10-BSTD-01

Re: October 14, 2011 Residential Staff Workshop - 2013 Building Energy Efficiency Standards (AHRI Comments on Residential Zoned Air-Conditioning)

Zonal Systems (red) Have Low EER

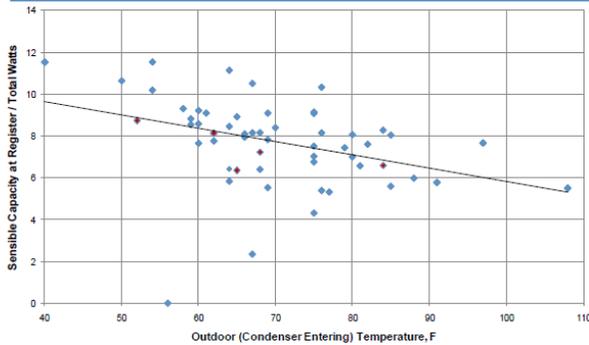
AHRI will argue that this study's conclusions do not look at the overall energy consumption of the home or how the system is operated. The presenters cite prior studies only to support their positions. The presenters completely ignore the same study's conclusions that zoning can save over 20% when zones are setback. If the goal of the CEC is to provide common sense energy reduction solutions, zoning with setback thermostats provides that ability automatically and not just in some cases, but in all cases.

These separate research projects both came to the same conclusions, zoning can add 20% (not the 35% as noted on this slide*) to energy costs if no setback is used and can provide 25% savings when setback is used. Attached is another chart from a more recent study on zoning showing a 30% reduction in cooling KWH with zoning. The presenters continue to report only on the increase in energy and not on the savings.

Figure 1

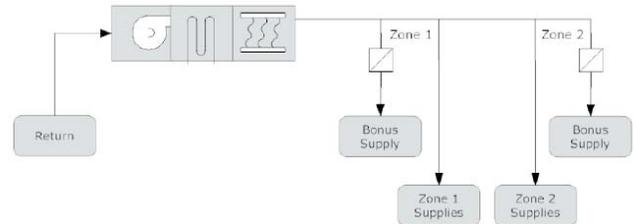
The slide says that 1/3 of the air will flow to the zone that does not need the air (three ducts open, one duct closed, each duct at 1/3 of the blower Cfm).

How is this going to happen? What are the duct sizing rules (for a particular blower table and set of pressure-dissipating devices, for a particular duct run geometry, and for a particular set of duct fittings); and/or what are the air balancing rules (the slide does not show hand dampers)?

In general, how can practitioners be sure that the proposed (Figure 1) design will always deliver adequate performance for any operating condition?

Zonal Systems (red) Have Low EER

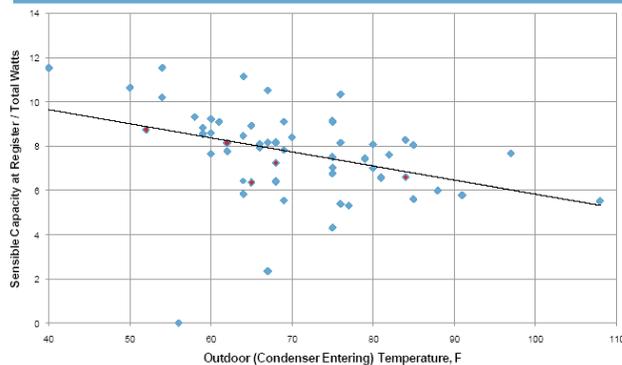
8.1 EER Comment

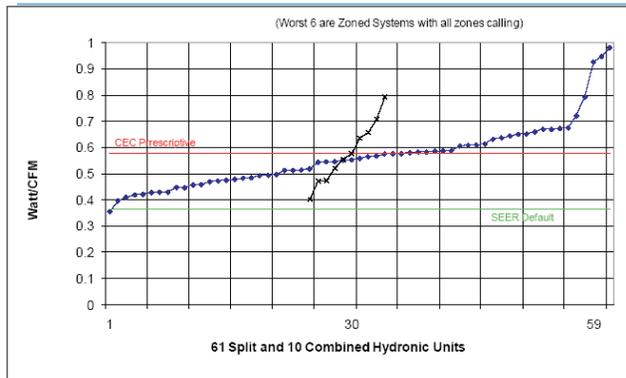
These tests may not be sensitive to equipment installation issues. Was the central equipment correctly sized or oversized? Was Cfm per nominal AHRI ton equivalent for one zone and multizone tests? Is refrigerant charge correct for one zone and multizone tests?

These tests do not seem to be apples-to-apples, as far as the issues that affect momentary system efficiency are concerned. And, the presentation implies that momentary efficiency is equivalent to seasonal efficiency.

This testing effort is affected by too many variables to pass judgement on air zoning. If all the marks on the graph were the same color, which ones should we be most concerned about, and why?

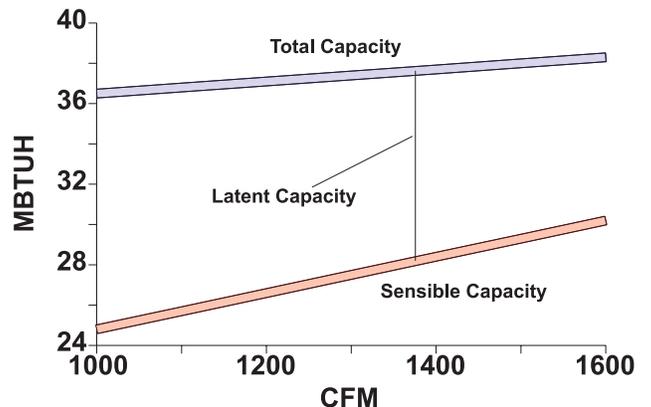
Locations like Charleston, SC, New Orleans, LA; and Mobile, AL favor 400 Cfm/Ton or less, for a colder coil and more latent capacity (not applicable to California).

There may be equipment that cannot operate at 350 Cfm/Ton.

Low Cfm per Ton translate s to a smaller value for maximum bypass air (explained later).

No Bypass and No Extra Cost

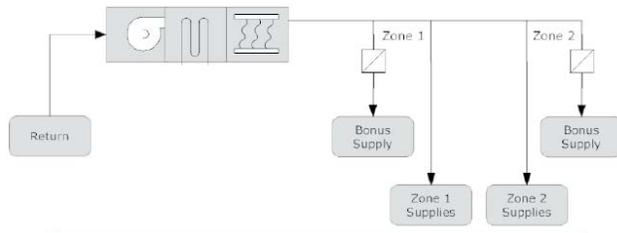
The Slide 21 solution (Figure 1) shows a duct system that has an undampered supply to each zone, and a dampered supply to each zone. There is no simple way to predict the behavior of this design.

- n Air outlet performance (throw and noise) depends on make, model and size. Some guidance is needed here.
- n In general, how can practitioners be sure that the proposed (Figure 1) design will always deliver adequate performance for any operating condition?
